Madera South High School – HVAC Improvement
Madera Unified School District

Date: 01/29/2025
NET POSITIVE Project No.: 1337
Client Project No.: **Base Bid 1**
DSA File No.: 20-H3
DSA Appl. No.: 02-122086

The following additions, deletions and revisions to the plans, specifications and Addenda shall become a part of the plans and specifications. It is the responsibility of the General Contractor to submit the information contained in this addendum to all subcontractors and suppliers. The Bidder shall acknowledge receipt of the Addendum in the Bid Proposal. (Addendum number of pages: **4** pages + **21** drawings + **0** attachments = **25** total pages).

SHEET NO:
M500

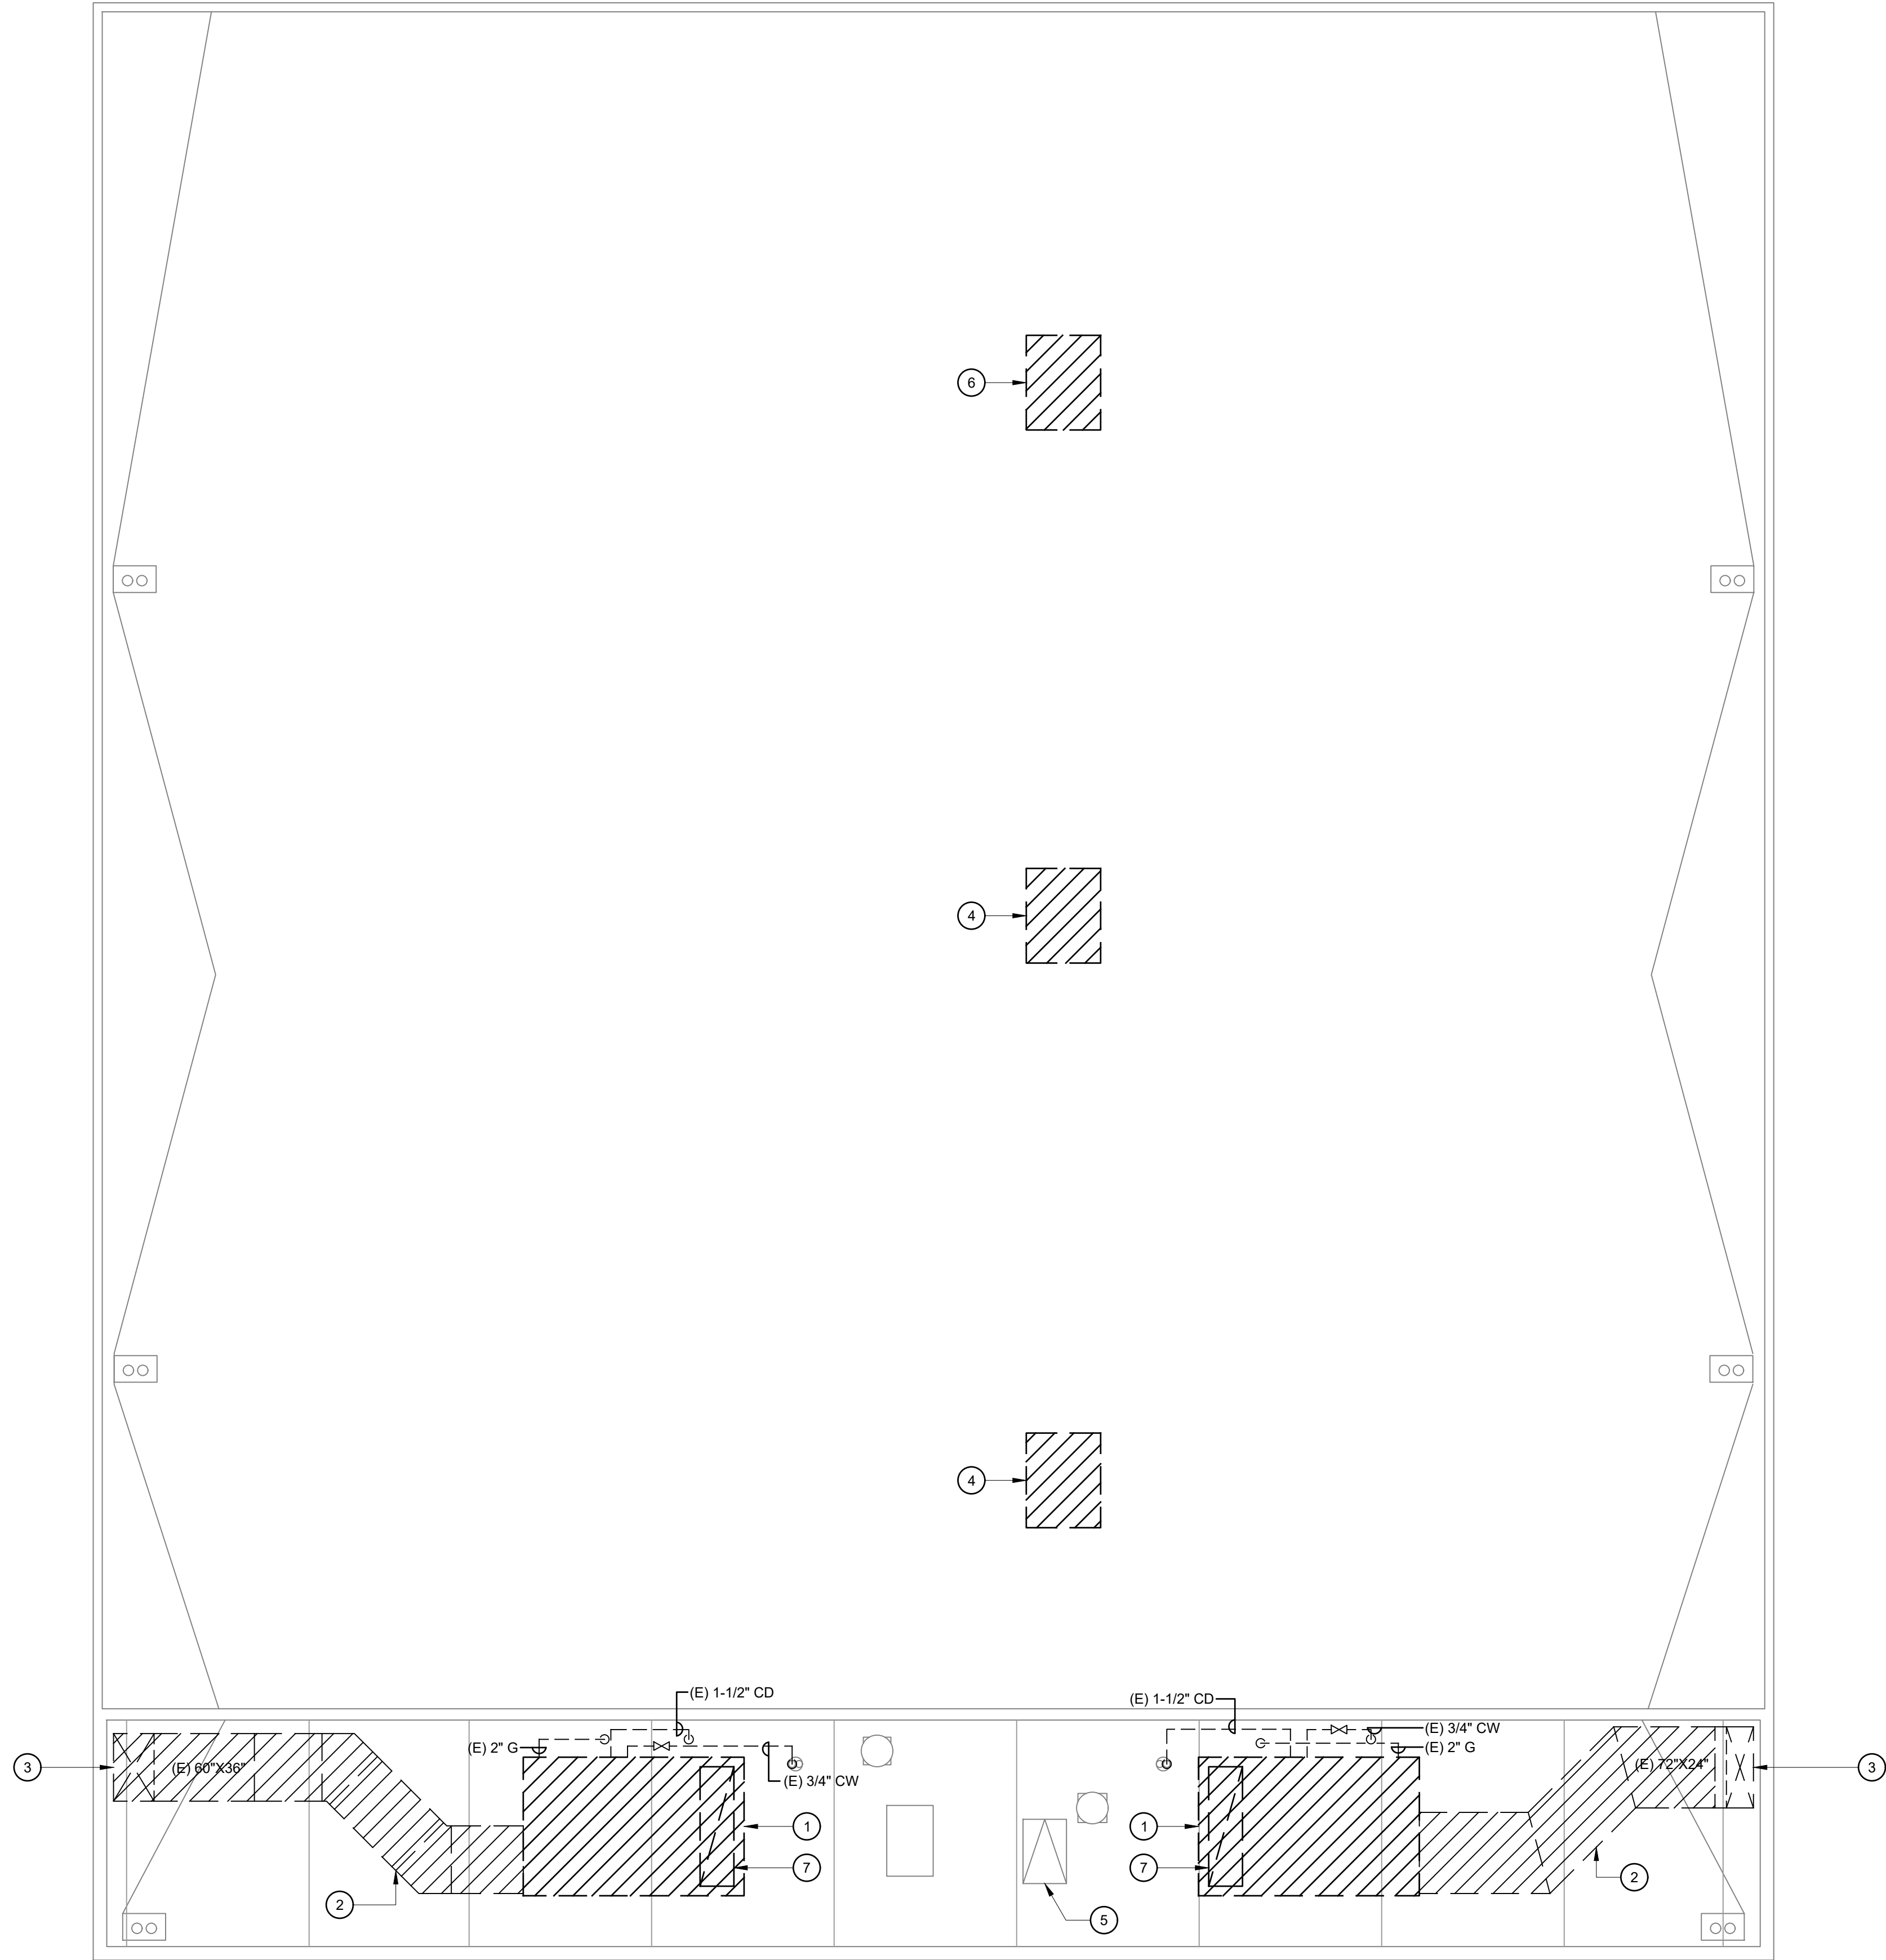
01-03: DRAWINGS, SHEET M500 – MECHANICAL ROOF PLAN – EAST GYM, revise as follows:

- A. Remove Drawing Sheet No. M500 in its entirety and replace with Addenda Drawing No. M500 AD01-03.
 - a. Revise Keynotes.

SHEET NO:
M510

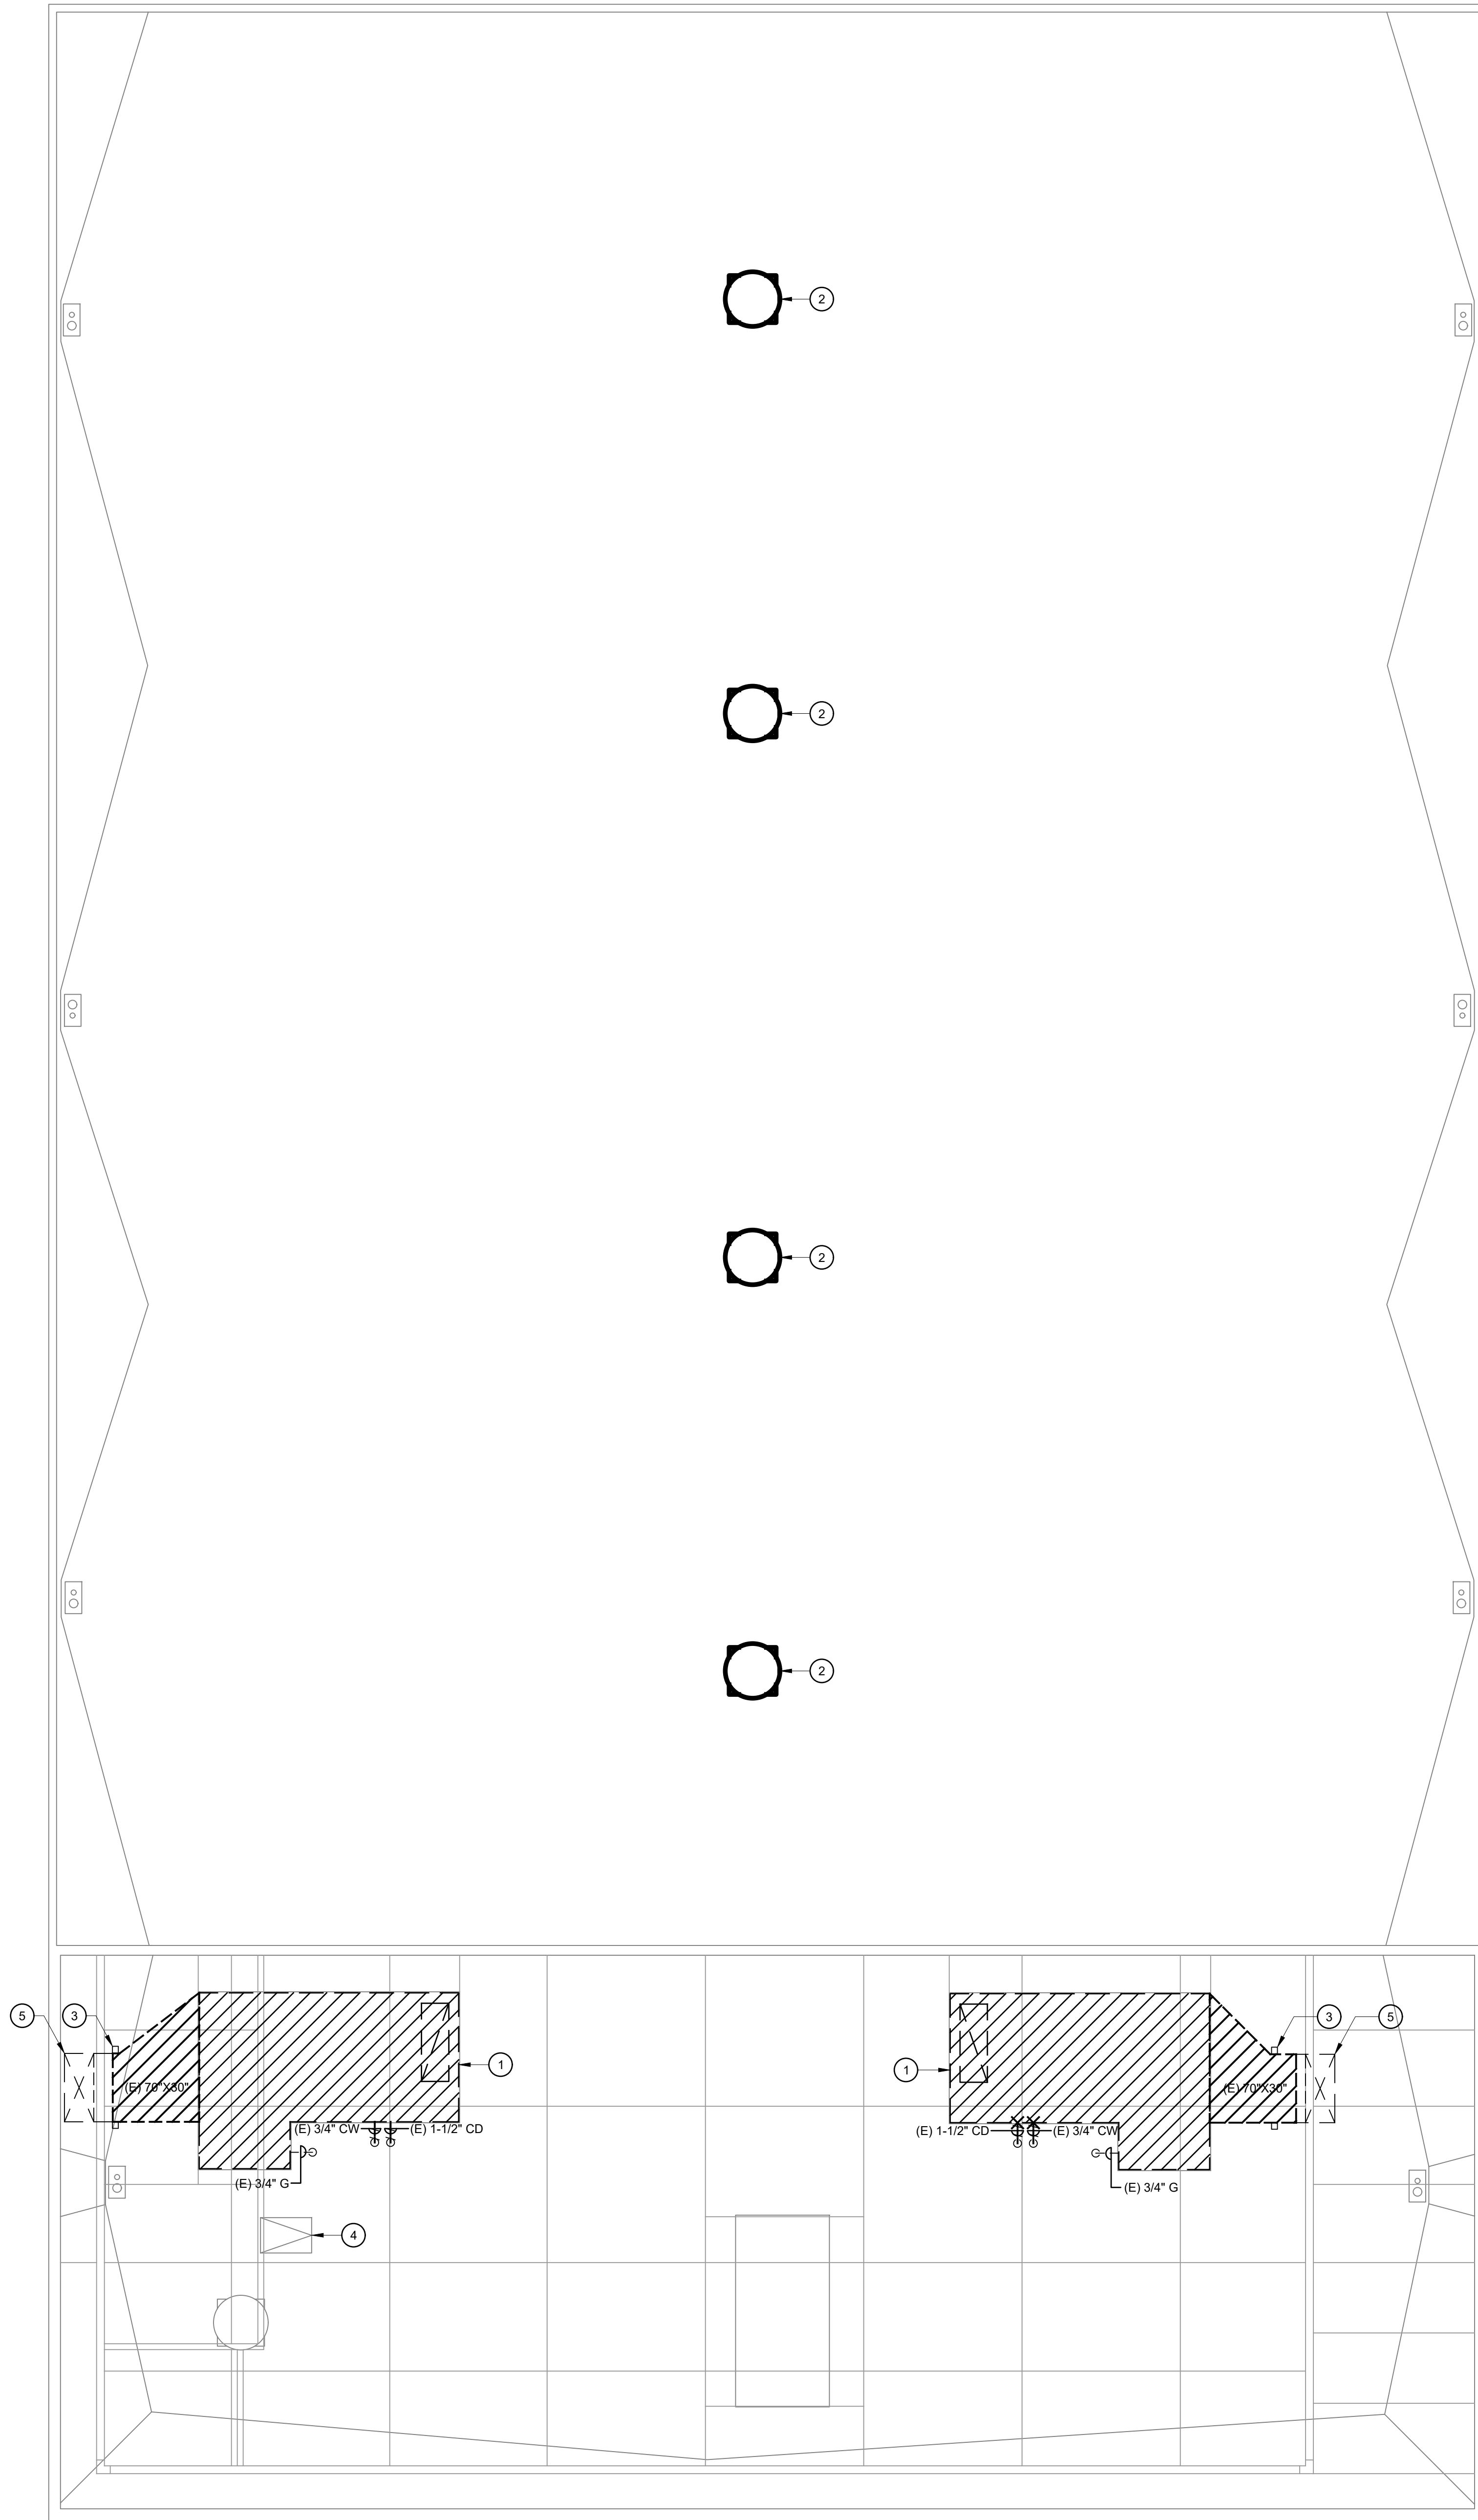
01-05: DRAWINGS, SHEET M510 – MECHANICAL DEMOLITION ROOF PLAN – WEST GYM, revise as follows:

- A. Remove Drawing Sheet No. M510 in its entirety and replace with Addenda Drawing No. M510 AD01-05.
 - a. Revise Keynotes.
